James A. FitzPatrick Nuclear Power Plant

Description and Evaluation of Proposed Changes

SUBJECT: Revise the James A. FitzPatrick Emergency Plan to Address the Permanently Defueled Condition

FIGURE 5-1 DEFUELED EMERGENCY ORGANIZATION INTERFACE

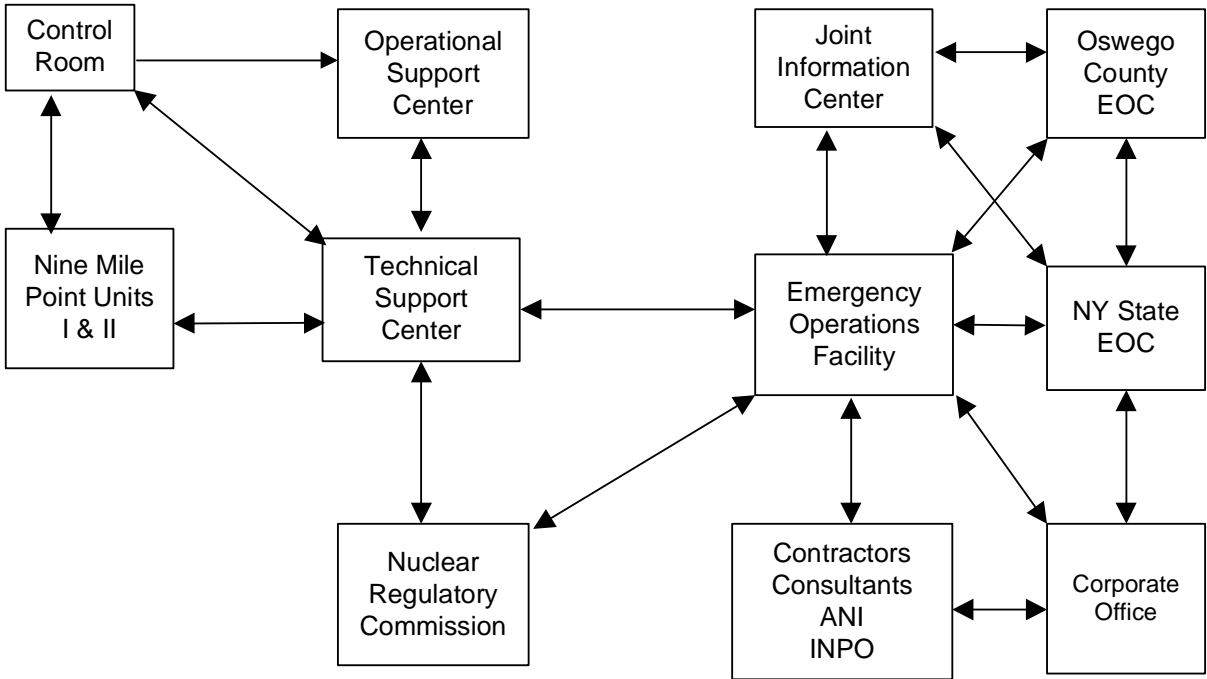
Section 5, Table of Contents	Figure 5-1 Emergency Organization Interface	Figure 5-1 Defueled Emergency Organization Interface	JAF will no longer be an operating nuclear power plant. The title change reflects the permanently defueled organizational structure.
Section 5, Table of Contents	Figure 5-2, J.A.F.N.P.P. Emergency Staffing On Shift Response Organization	Figure 5-2, J.A.F.N.P.P. Defueled Emergency Staffing On Shift Response Organization	JAF will no longer be an operating nuclear power plant. The title change reflects the permanently defueled organizational structure.
Section 5.1	Normal Operation Organization	Permanently Defueled Organization	JAF will no longer be an operating nuclear power plant. The title change reflects the permanently defueled organizational structure.
Section 5.1	The James A Fitzpatrick Nuclear	The James A Fitzpatrick Nuclear	JAF will no longer be an

Figure 5-1: Changed title to DEFUELED EMERGENCY ORGANIZATION INTERFACE

FIGURE 5-2 J.A.F.N.P.P. DEFUELED EMERGENCY STAFFING ON SHIFT RESPONSE ORGANIZATION

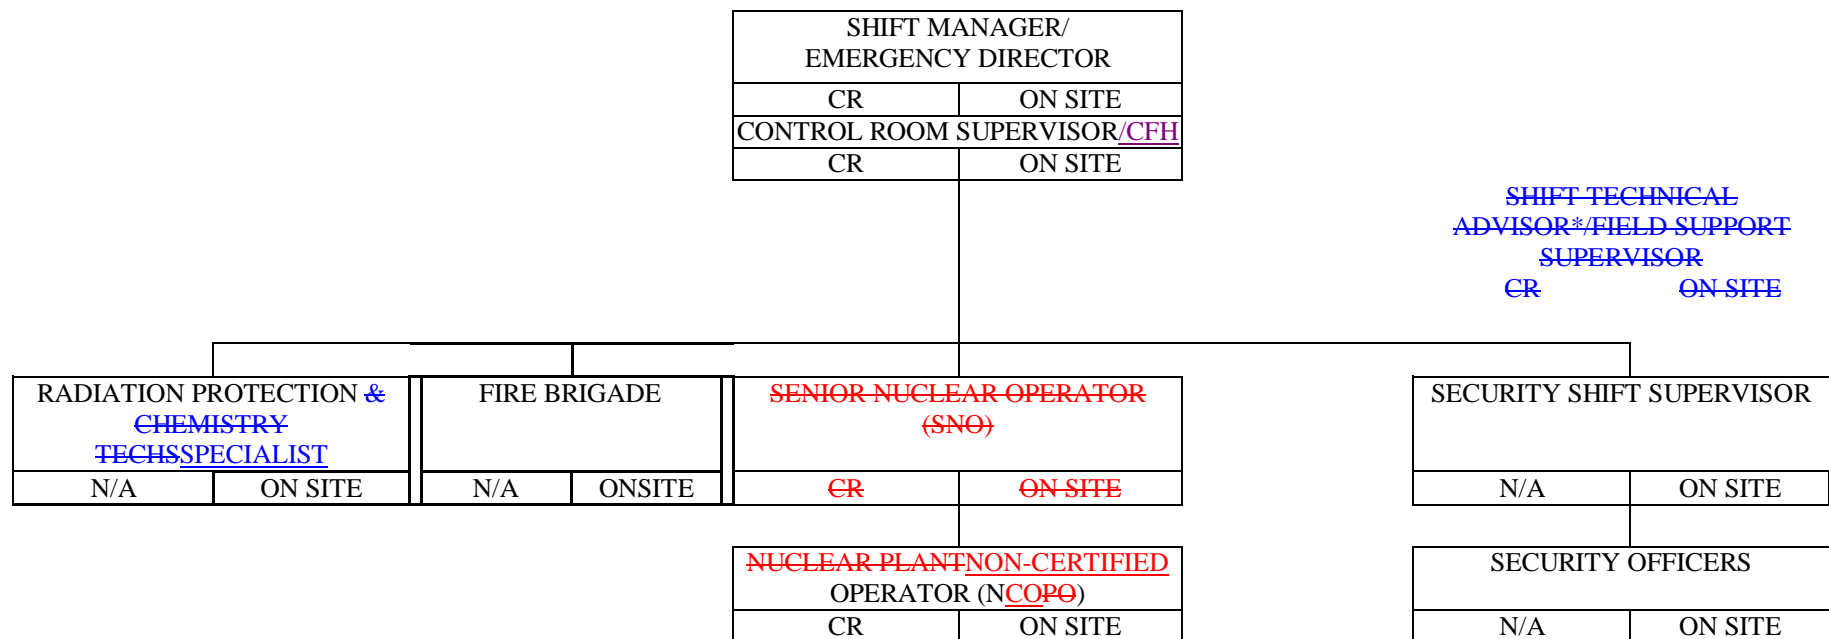
The proposed changes to the on-shift organization are identified in Section 5.1, "Normal Plant Organization," of the JAF Emergency Plan, Table 5-1, and Figure 5-2, "Defueled Emergency Staffing On Shift Response Organization" in Attachment 3.

Section 5.7	Figure 5-2, Emergency Staffing On Shift Response Organization	Figure 5-2, J.A.F.N.P.P. Defueled Emergency Staffing On Shift Response Organization	JAF will no longer be an operating nuclear power plant. The title change reflects the permanently defueled organizational structure.
Figure 5-1	Figure 5-1 Emergency Organization Interface	Figure 5-1 Defueled Emergency Organization Interface	JAF will no longer be an operating nuclear power plant. The title change reflects the

Figure 5-2: Changed title to DEFUELED EMERGENCY STAFFING ON SHIFT RESPONSE ORGANIZATION
